Development Review Committee
Government Center Complex
Conference Room, Building A
Sept. 25, 2013 - 4 p.m.

MEMORANDUM

SUBJECT: Case No. SP-0087-2012/S-0047-2012, Village at Candle Station

**CONCEPTUAL PLAN 0040-2013. New Town Section 9 (Settlers Market) Residential
– Master Plan Consistency Determination
Staff Report for the September 25, 2013, Development Review Committee Meeting**

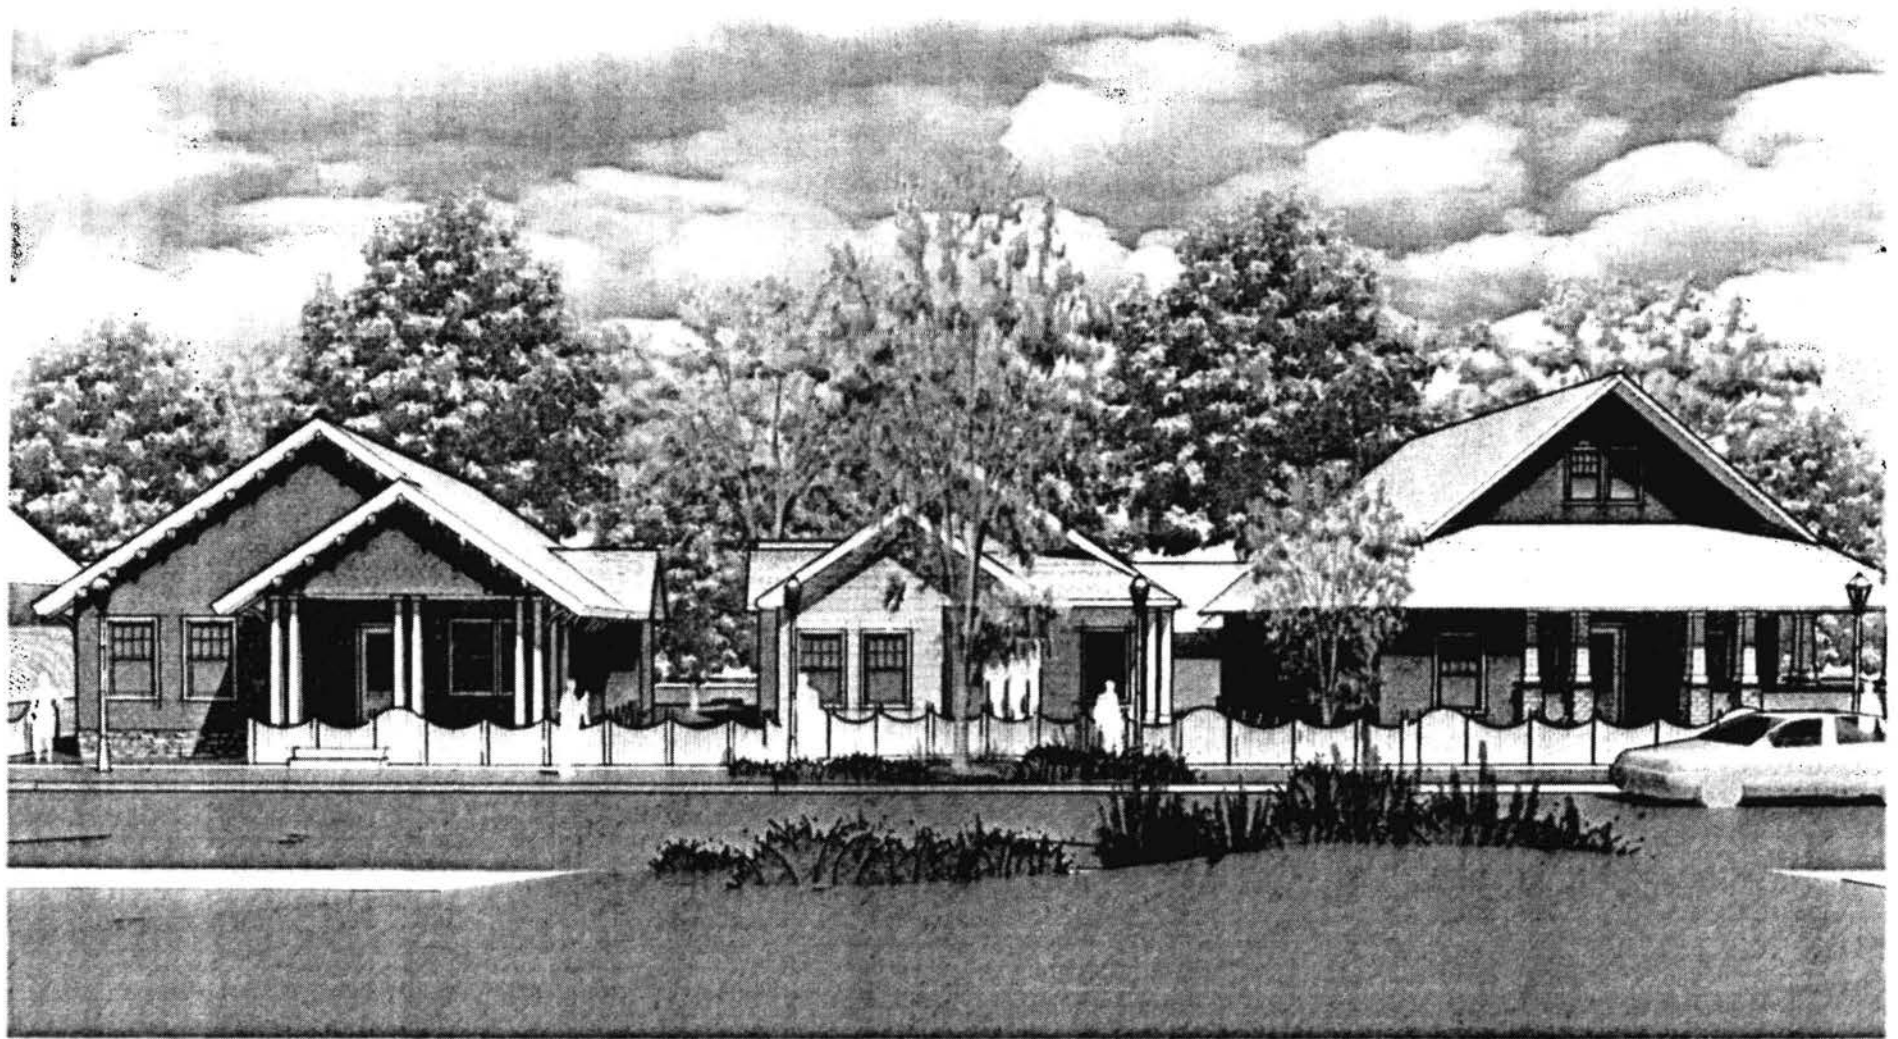
On August 28, 2013, the applicant requested deferral of this application in order to revise architectural elevations for the proposed single-family units with front-loaded garages (up to 10 lots are proposed to have front-loaded garages). On September 19, 2013, the applicant submitted a revised drawing (Attachment No. 5) which is similar to an architectural elevation (Attachment No. 2) submitted on June 24, 2013, as part of the Draft Design Guidelines for The Village at Candle Station.

As noted in the January 30th and August 28th staff's reports staff continues to find that the proposed changes, including the proposed ten single-family detached units with front-loaded garages and elimination of the shared driveways, inconsistent with the adopted master plan and supplemental materials submitted and adopted as part of the rezoning application for Candle Factory. Staff finds that the proposed changes are substantial and that these should be subject to legislative review and approval by the Planning Commission and Board of Supervisors.

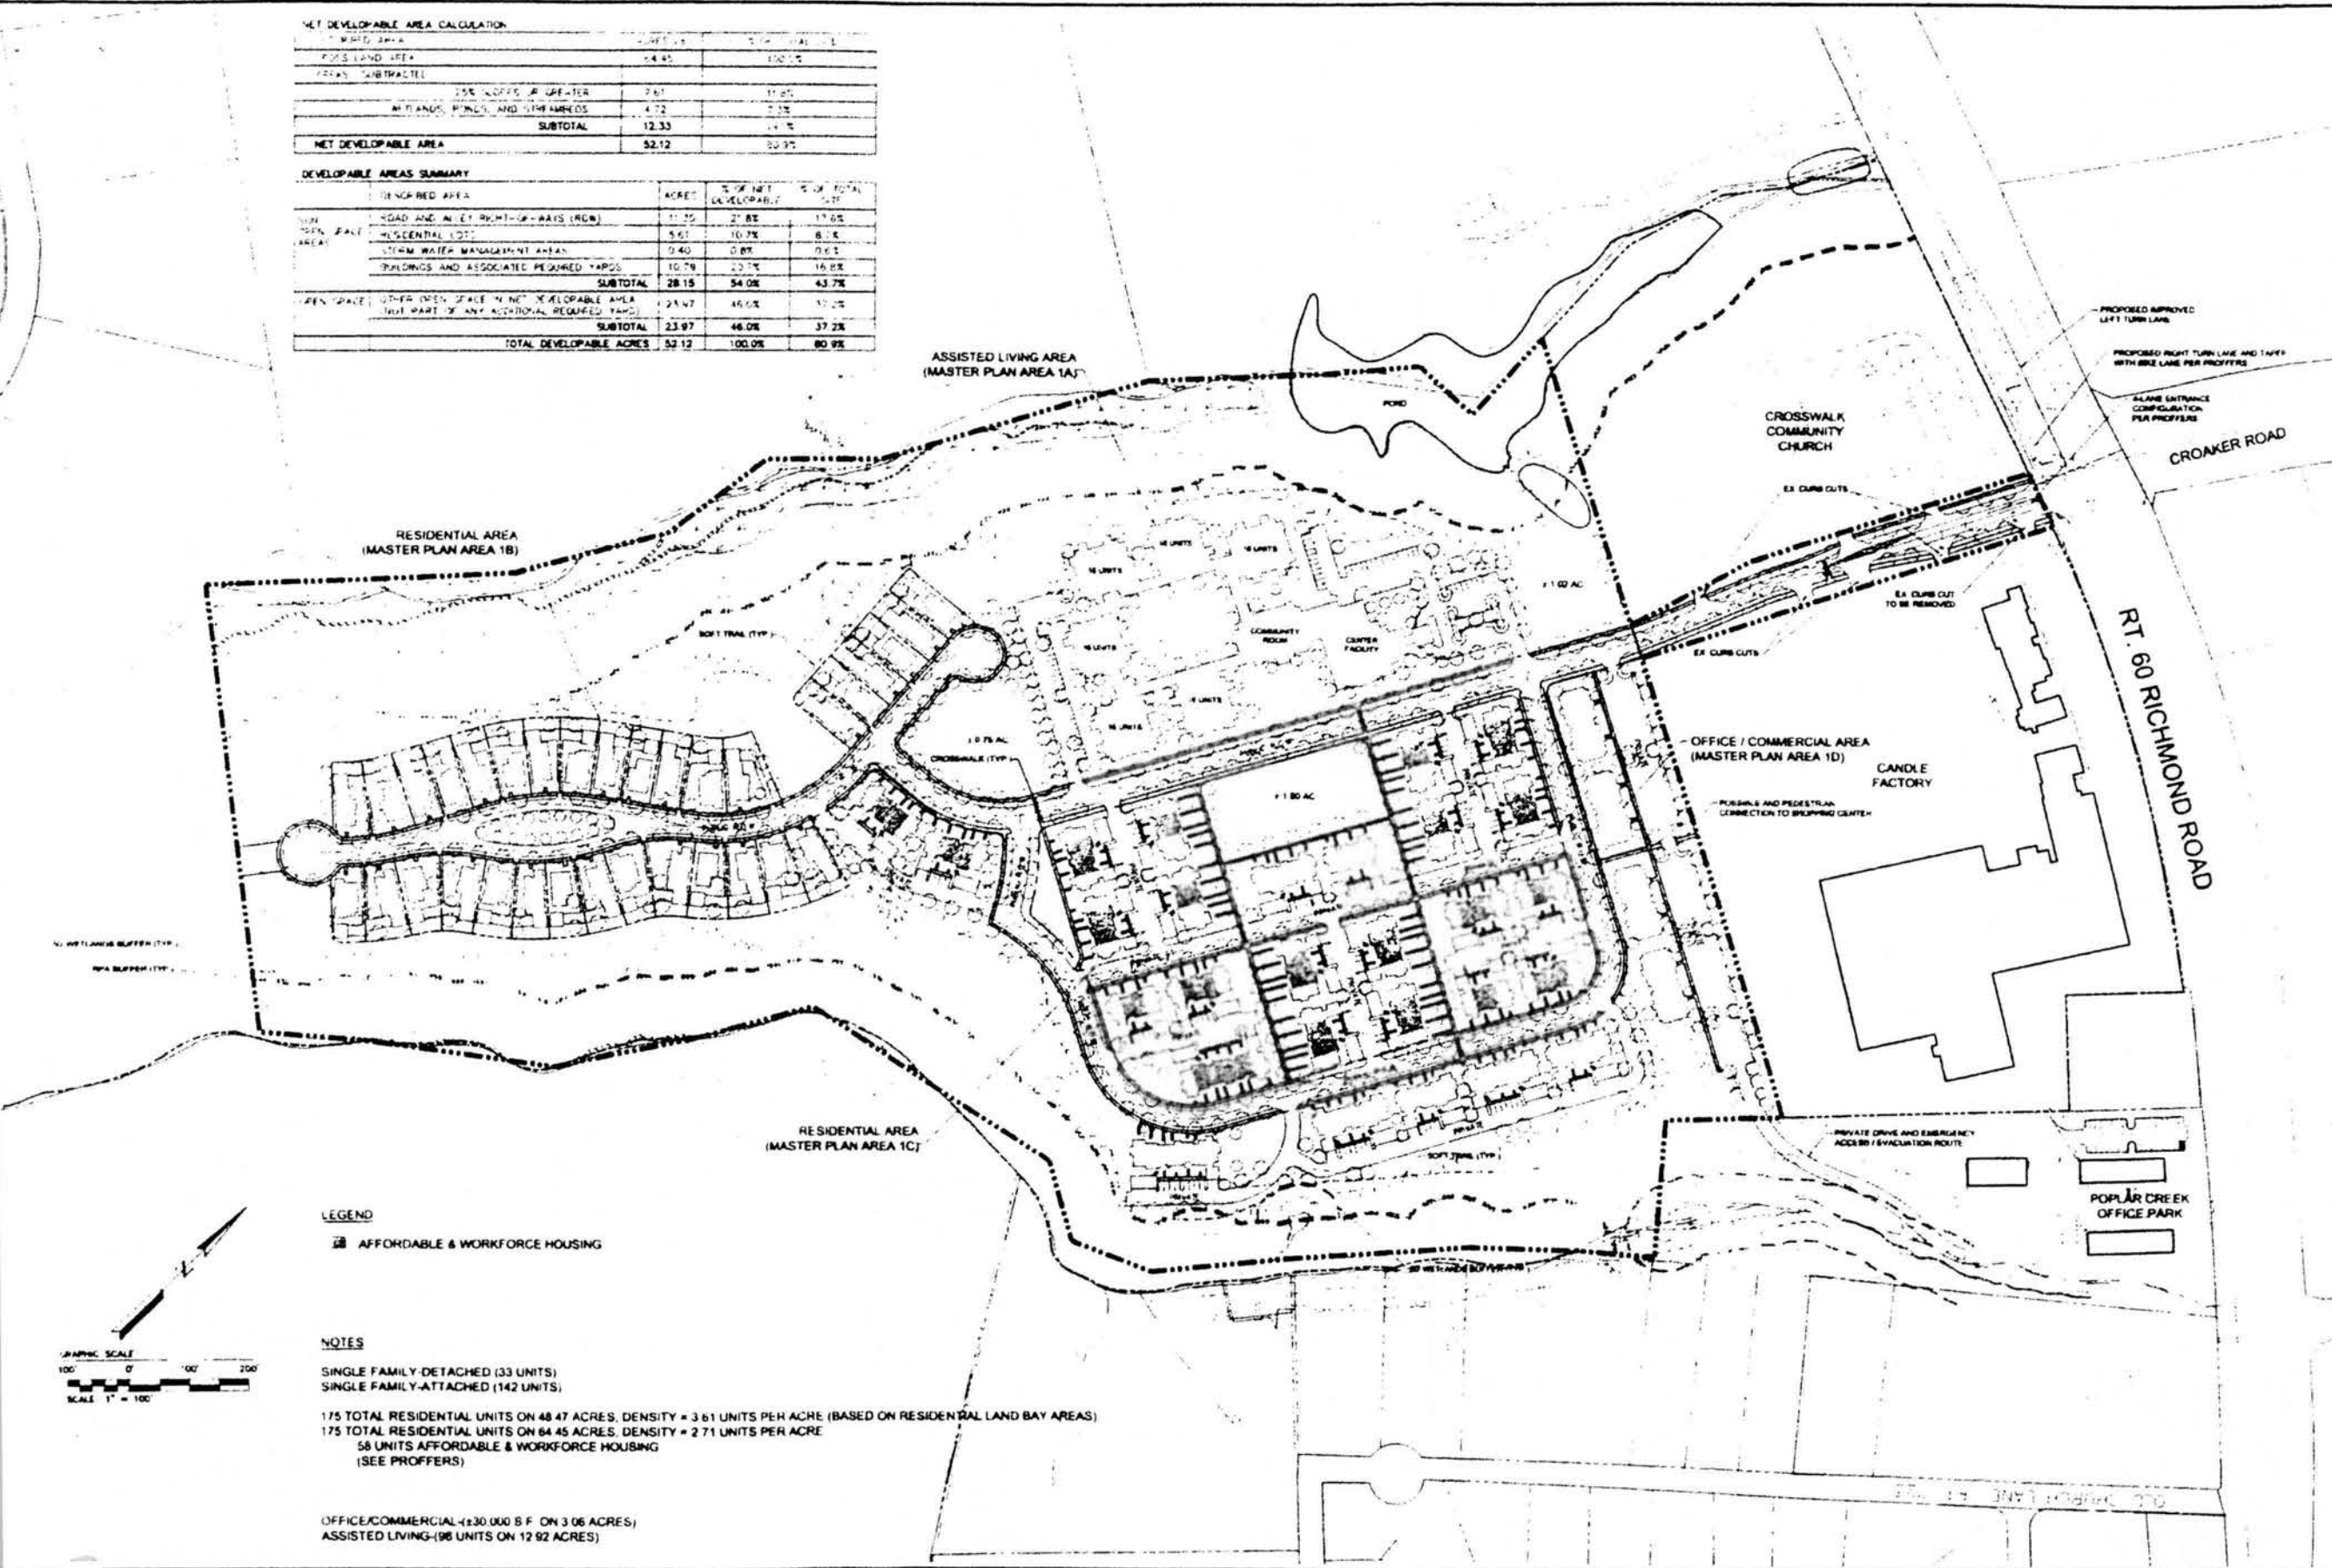
Summary of changes made to the Master Plan by the applicant and approved by the DRC on March 5, 2013

- 1. The width of some of the thirty-three single-family lots will be increased; all lots are sequentially placed on a continuous row which fronts both sides of a public right-of-way (This area is labeled on the revised exhibit as Area no. 1).**

- 2. Relocation of ten townhome units (This area is labeled on the revised exhibit as Area no. 2).**

- 3. Changes to the townhome cluster area (This area is labeled on the revised exhibit as Area no. 3).**

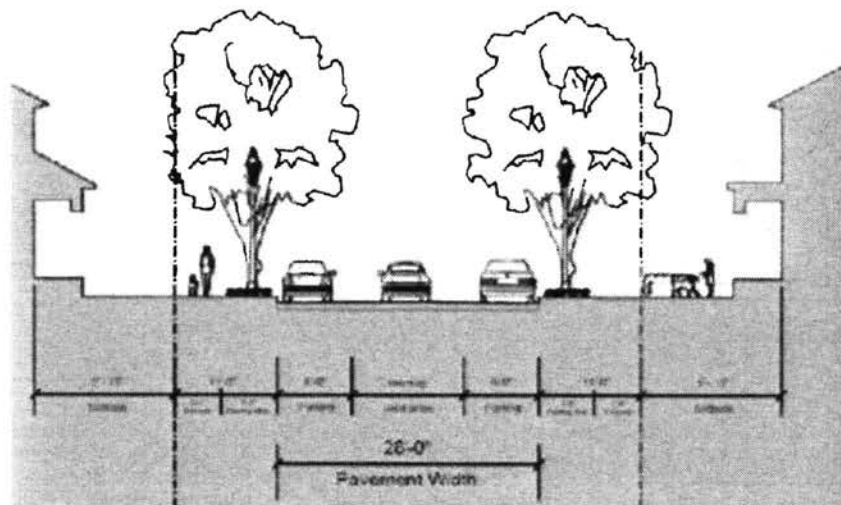
The proposed amendments maintain this intent; and, in our opinion, achieve it more fully. Additional green space has been added to create an even stronger network of linked park land. As indicated on the image below, the central transitional green space is now complemented by subordinate spaces that range from formal promenades, courtyards and gardens to informal meadows and buffers.

- ❖ A need to move townhouse units further from the existing BMP retaining walls for safety, preservation of the structural integrity and access to the wall.
- ❖ A desire to front more units on formal public ways.
- ❖ A desire to allow more view of preservation areas.

In doing so, some townhomes will present a side facade to a public street. This will allow us to further enhance the project by including architectural treatment of these facades so as to enliven and reinforce the streetscape.

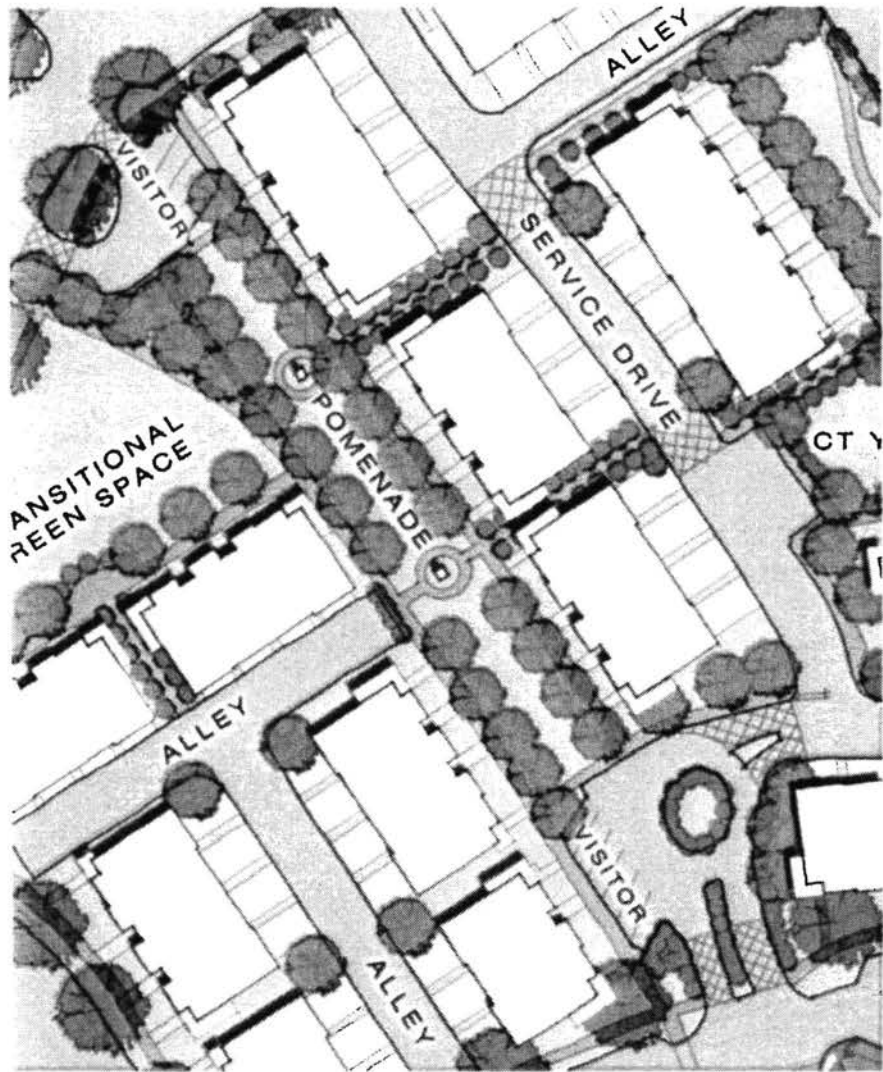
The approved master plan included a cross road, "Yield Street," which connects Casey Boulevard to Merchants Way. Yield Street is designed with a 28'-0" paved width with parallel parking available on both sides. So, the remaining space between the parked cars consists of narrow "yield lanes," hence the name of the street.

The proposed amendments replace the vehicular Yield Street with a formal pedestrian "Promenade" which maintains its character and use as a formal public way, but also enhances the amount of green space and quality of setting for many of the units. Below is a graphic depicting this modification:

- Yield Street, as a vehicular way, is not a requirement for VDOT and provides only limited benefit to the public as a thoroughway, given the tight dimensions.

- The right-of-way on the master plan presented two parallel sidewalks which we are proposing to maintain and, in fact, enhance.
- The proposed modified layout more closely aligns with VDOT's intersection requirements of 125-ft minimum separation than the current plan; with only one waiver necessary.

- The on-street parking along Yield Street that will be lost in the proposed layout is more than offset with distributed parking throughout the development. In fact, the total amount of parking proposed exceeds JCC requirements and provides necessary parking for residents and guests off-street, without reliance on on-street parking.

- While the conversion of Yield Street to a pedestrian way, or "Promenade," will inhibit access to the front of some units by fire and life safety vehicles, alternative accommodations have been

incorporated into the plan. These include: a widened service road behind the units (without on-street parking) and small visitor parking areas at each end of the Promenade.
